Sisters of Notre Dame Campus, 13105 Watertown Plank Road.

Chairman Olson stated the goal for this discussion is provide additional feedback to the Mandel Group and Enberg Anderson related to the materials that were presented at the March 16th, 2021 Building Board meeting.

Proximity of building to street

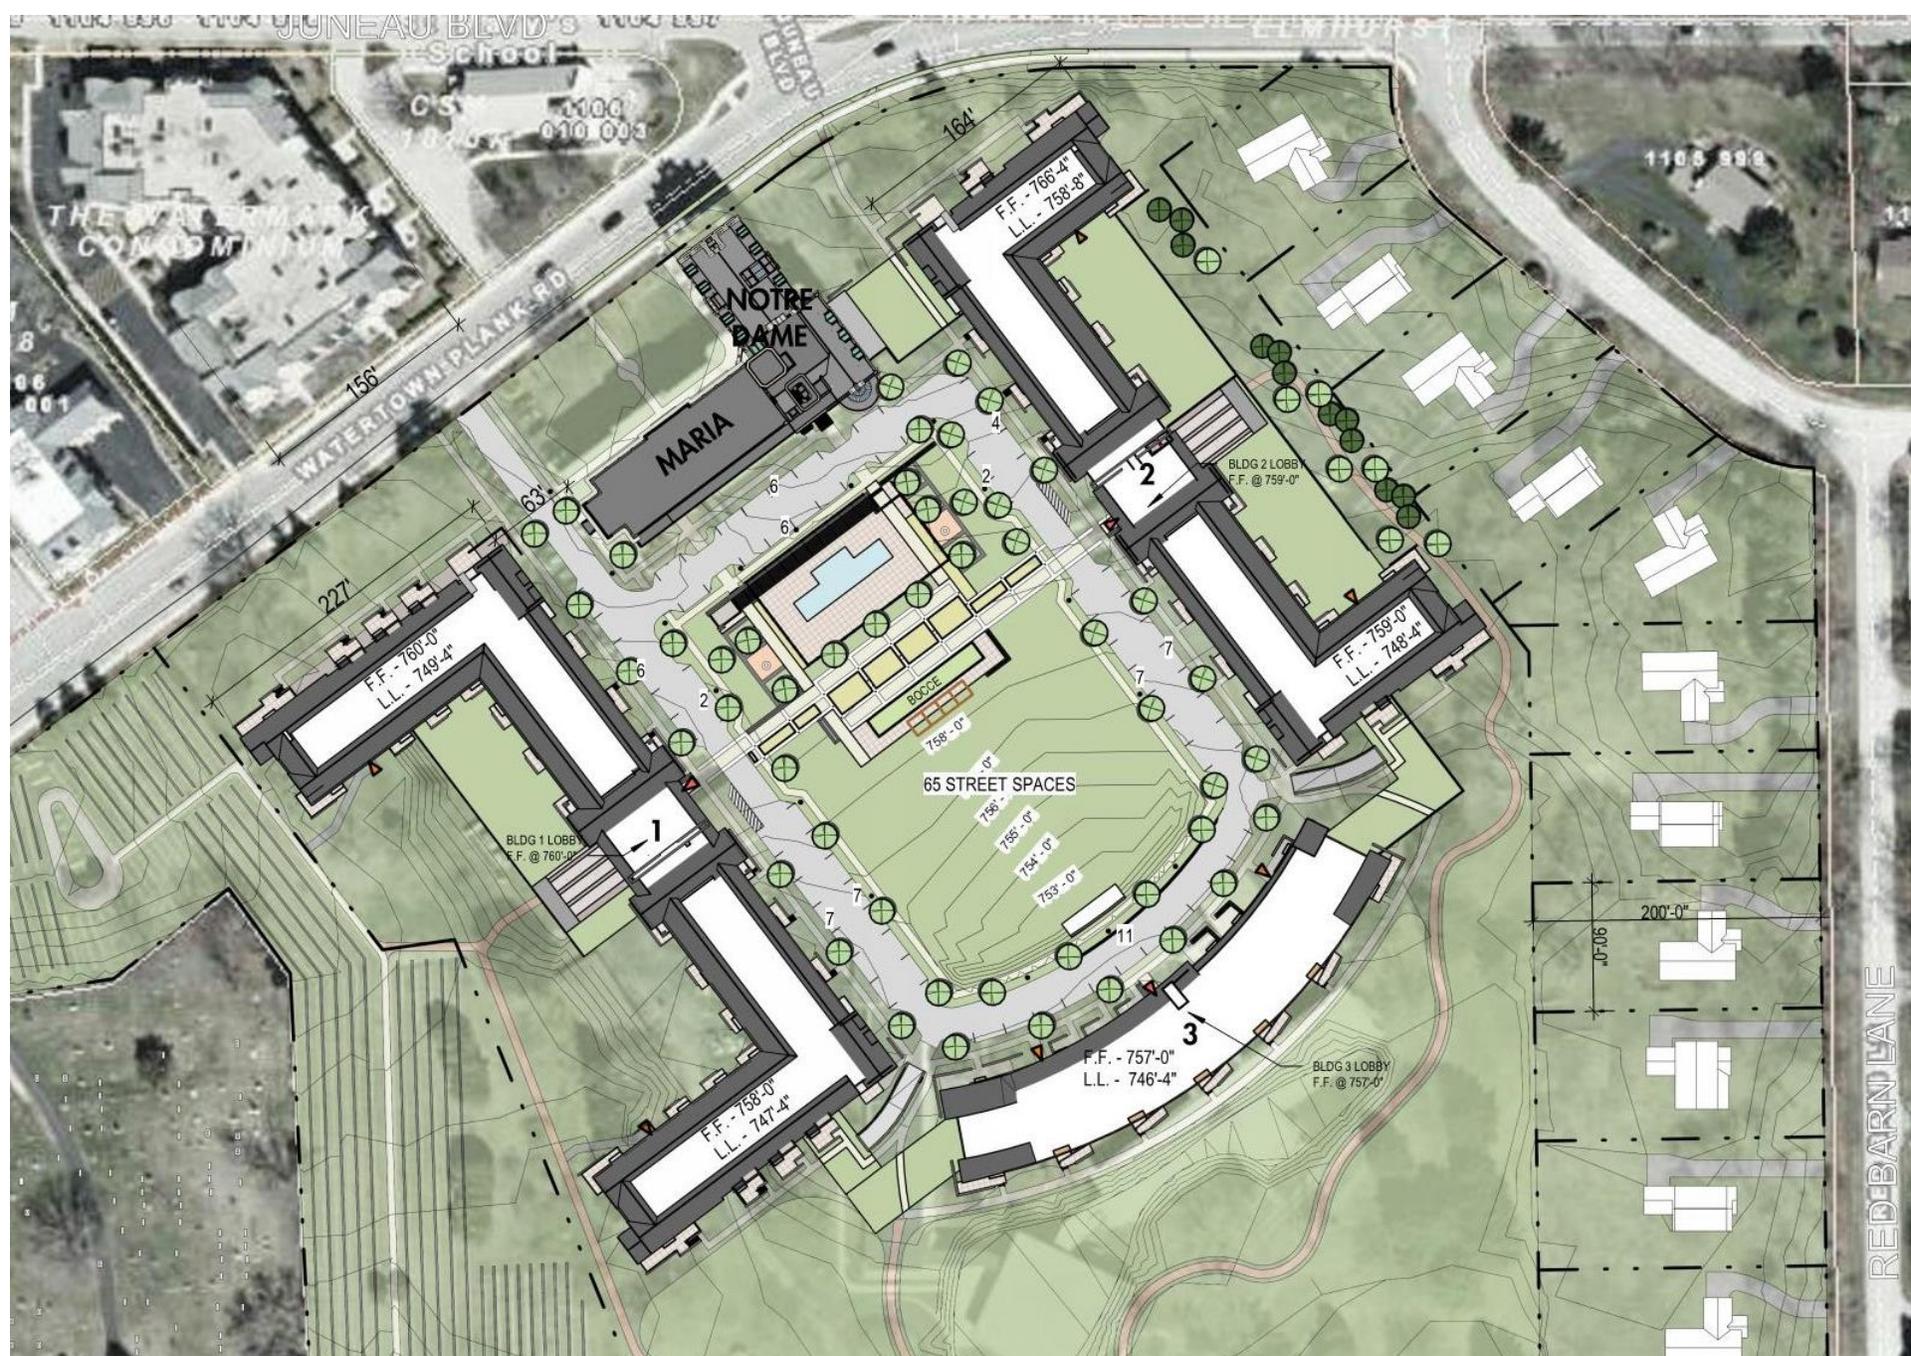
Mr. Koleski stated there was discussion related to the backside of Building One and Two. What is going to be done with the porches and how do they blend into the overall structure. Also, not being able to see the size of the proposed stone in comparison to the existing stone on Maria Hall is a challenge to understand visually. Is there an opportunity to scale the stone to demonstrate what will be done one site?

Mr. Koleski noted a rendering of nighttime conditions was discussed. Specifically, how will the development appear in the evening with the internal outdoor lighting illuminated?

Mr. Thedford noted that the landscaping plan has not been discussed at length. Greater focus will need to be given in order to determine how the landscaping plan engages with the site plan.

When measured to the edge of the road (not property line):

Existing Buildings

Watermark: ~35'
 Notre Dame: ~23'
 Maria Hall: ~105'

Proposed New Buildings

Building 2 at closest point of screened porch: 37'
 Building 2 at furthest point (gable end): 108'
 Buildign 1: ~100'-110'

Proximity of building to street

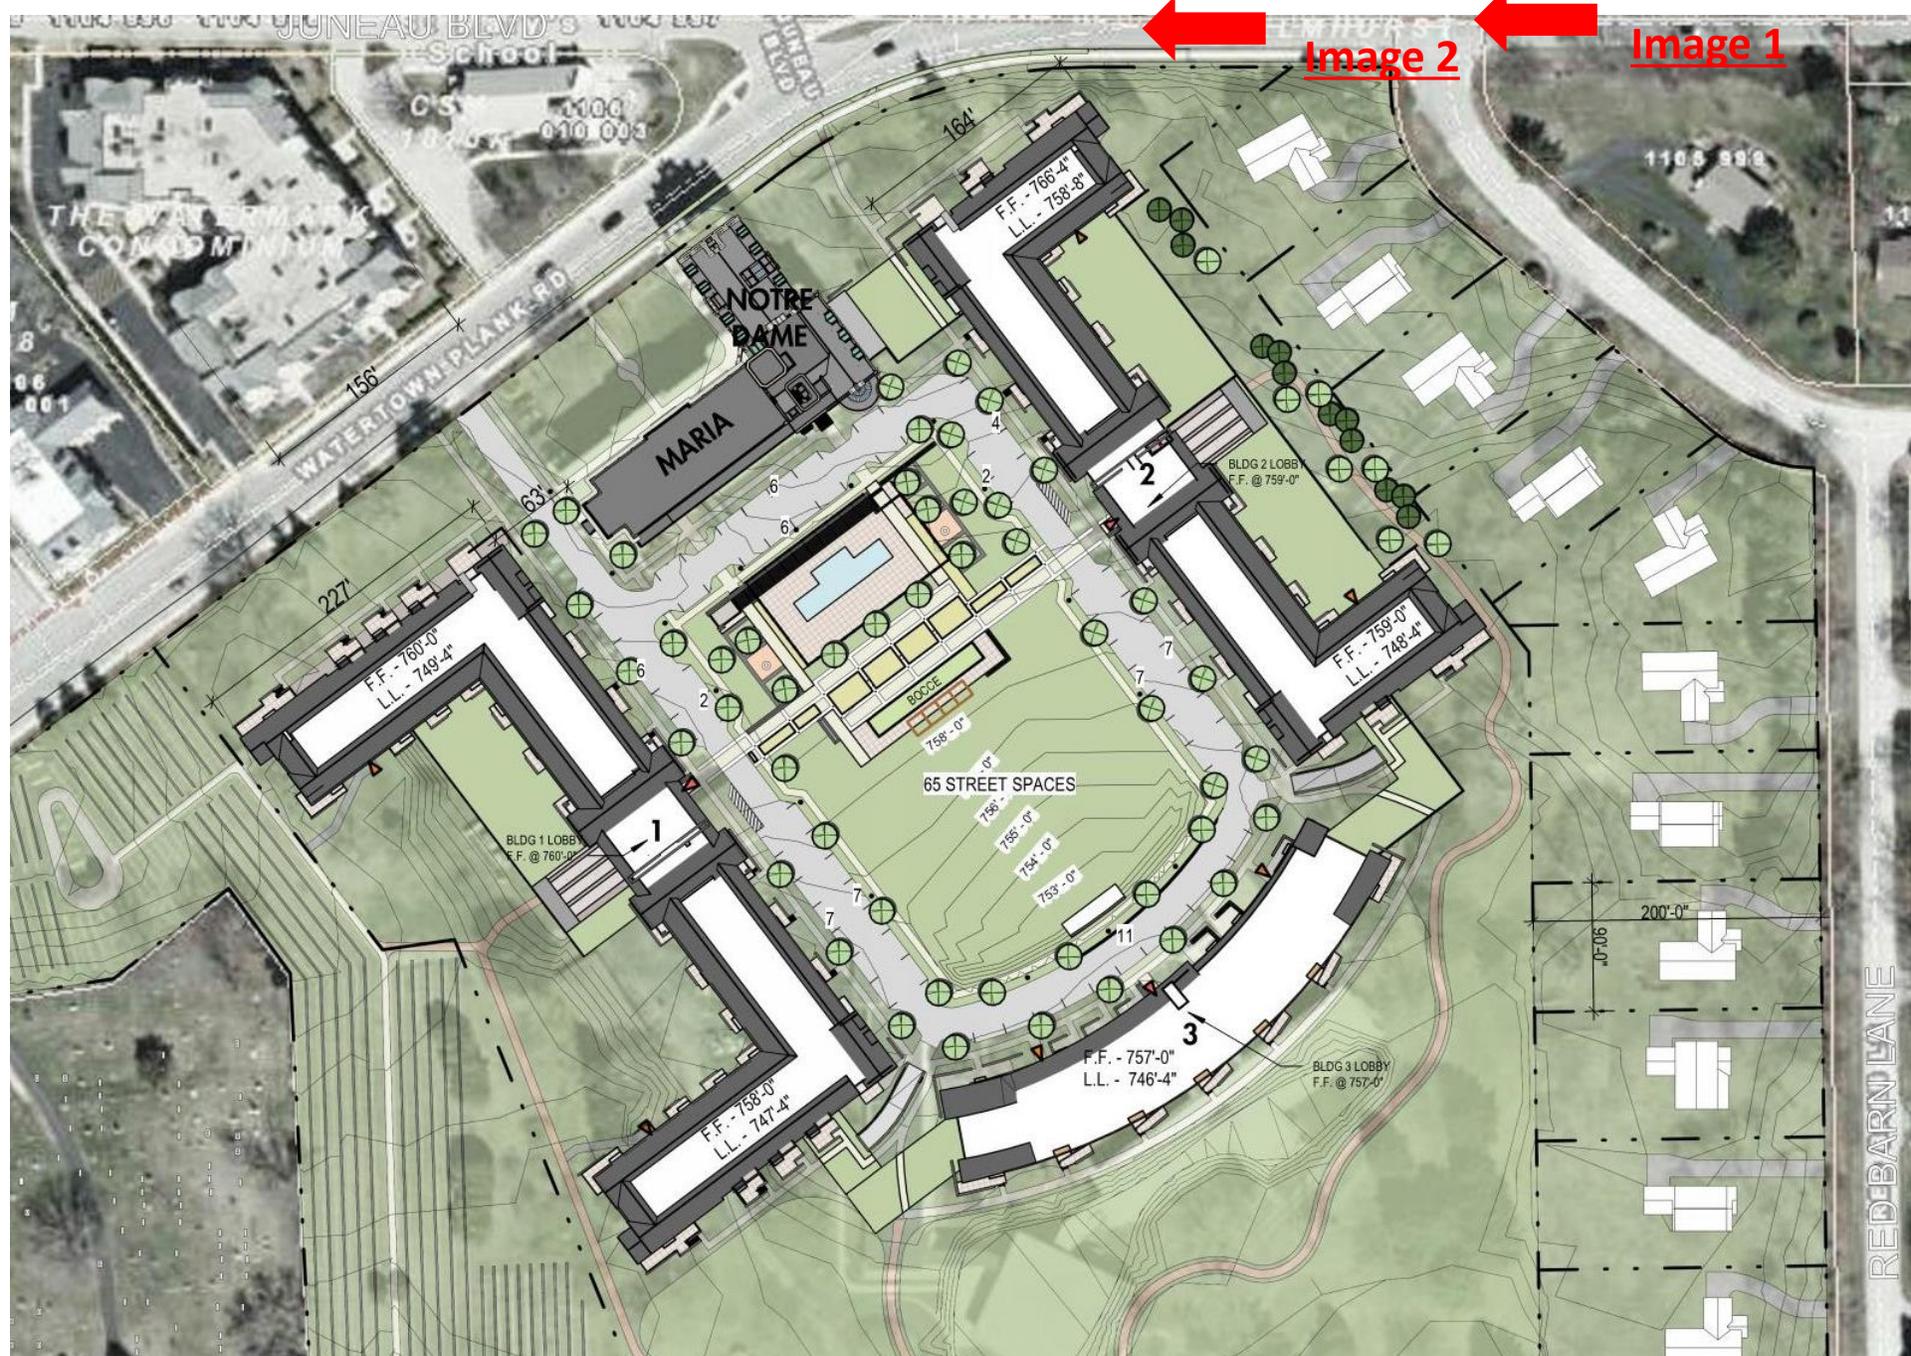
Mr. Falsetti noted the approach of Building Two, heading westbound on Watertown Plank Road deserves additional study.

Mr. Thedford stated the board needs to begin addressing the topic of screening and the solidarity of the landscaping as it bridges into the building as you approach from the east to the west.

When measured to the edge of the road (not property line):

Existing Buildings

- Watermark: ~35'
- Notre Dame: ~23'
- Maria Hall: ~105'

Proposed New Buildings

- Building 2 at closest point of screened porch: 37'
- Building 2 at furthest point (gable end): 108'
- Buildign 1: ~100'-110'
